Memo

Re: Part 8 proposal, Reference PT8LL328 – The development will consist of:

**MAYOR'S REPORT & RECOMMENDATION IN ACCORDANCE
WITH SECTION 179 3(a) OF THE PLANNING & DEVELOPMENT
ACT 2000 (AS AMENDED)**

Planning Ref: PT8LL328 - Toppins Field Development

Design Issues Identified

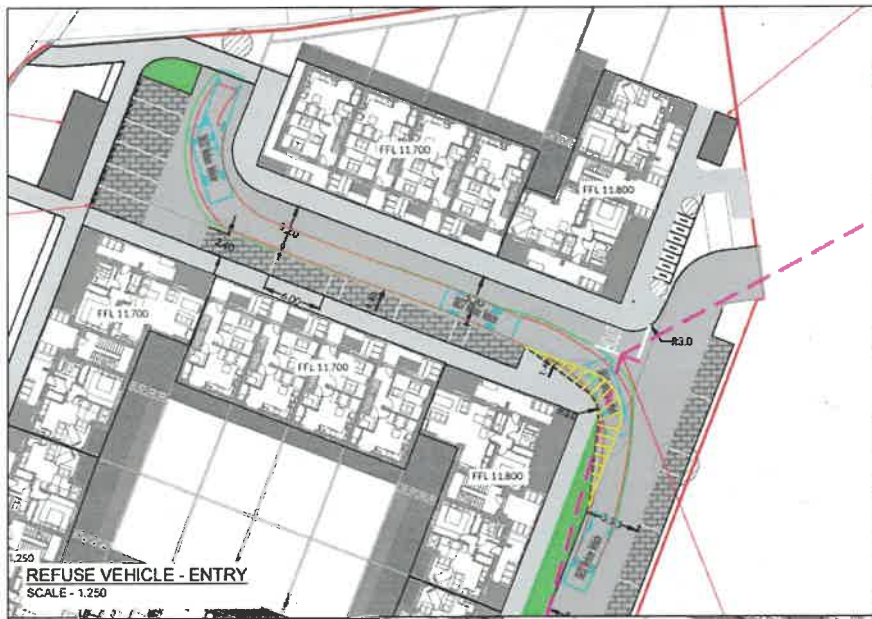
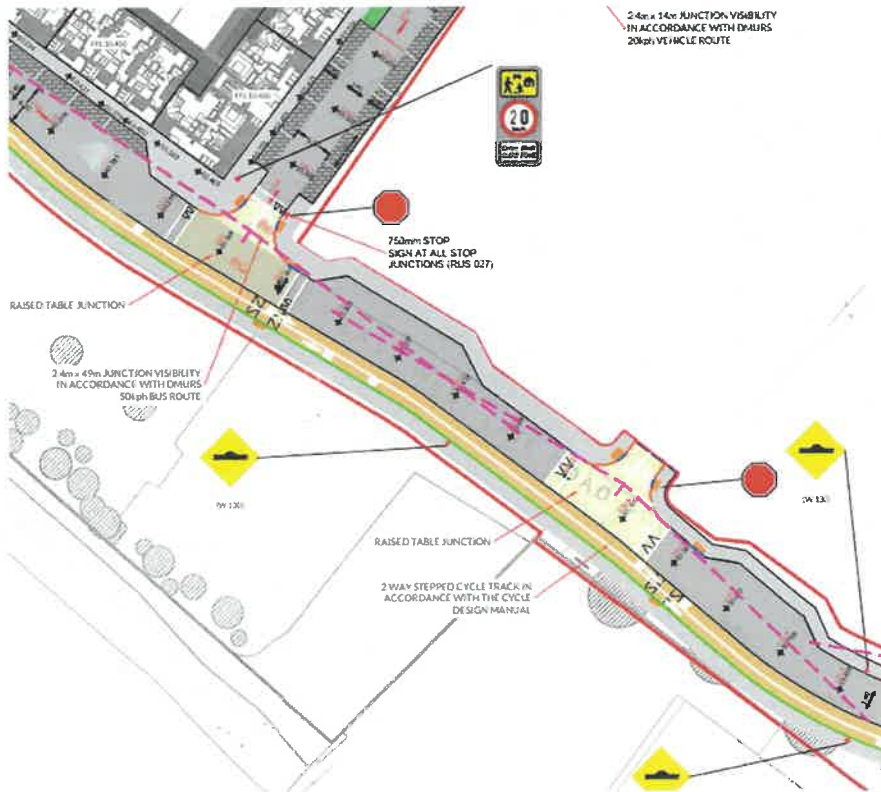
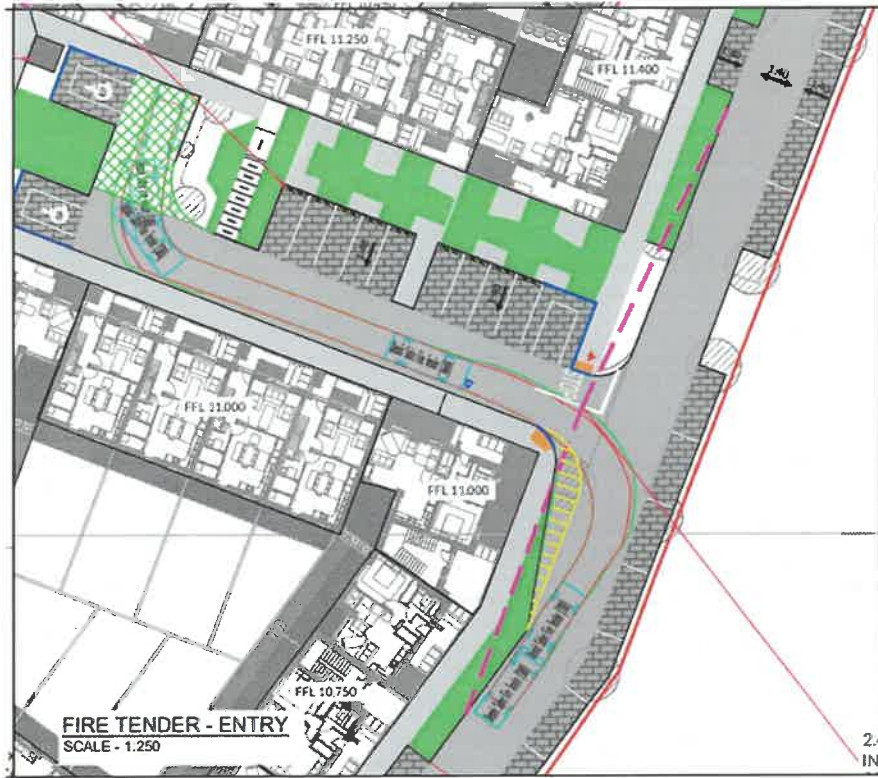
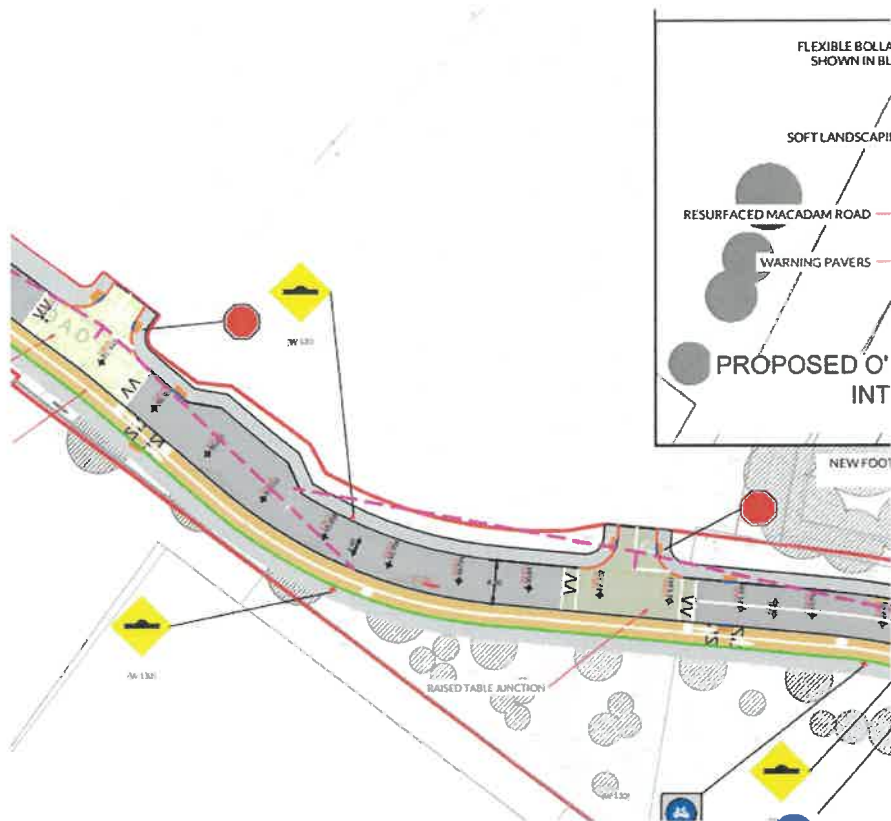
- Junction layouts not compliant with DMURS
Several junction designs do not align with the principles of the *Design Manual for Urban Roads and Streets (DMURS)*. The layouts as currently designed prioritise vehicle movements over pedestrian safety and comfort.
In particular, the use of hatched road markings to artificially form junction radii results in wider pedestrian crossing distances. The existing arrangement—where the footpath should continue across the side road to establish pedestrian priority—has not been correctly implemented.

- Missing tactile paving at signalised junction refuge islands
Tactile paving is absent from refuge islands at the main signalised junction. This omission reduces accessibility for visually impaired users and is not in accordance with DMURS guidance or relevant accessibility standards.

- Incorrect sightline representation
Sightlines at several junctions have been illustrated incorrectly in the design drawings. When adjusted to reflect DMURS-compliant approach speeds and sightline distances, the revised lines of sight show that the proposed parallel inset parking bays obstruct driver visibility.

- **Non-compliant Combined Speed Ramp and Pedestrian Crossing detail**
The submitted details for the combined speed ramp and pedestrian crossing do not comply with the *TII Pedestrian Crossing Specification and Guidance*. The ramps and crossing elements must be designed in accordance with TII guidance to ensure correct geometry, visibility, and accessibility.

- **Footpath construction detail not acceptable**
The proposal to construct footpaths using paved finishes to architectural standards is not permitted. Footpaths should be constructed using concrete to comply with local authority standards and to ensure consistency, durability, and accessibility for all users.

We will require an email from you to confirm that these details will be dealt with at detailed design stage so that I can sign off to our Planning Section
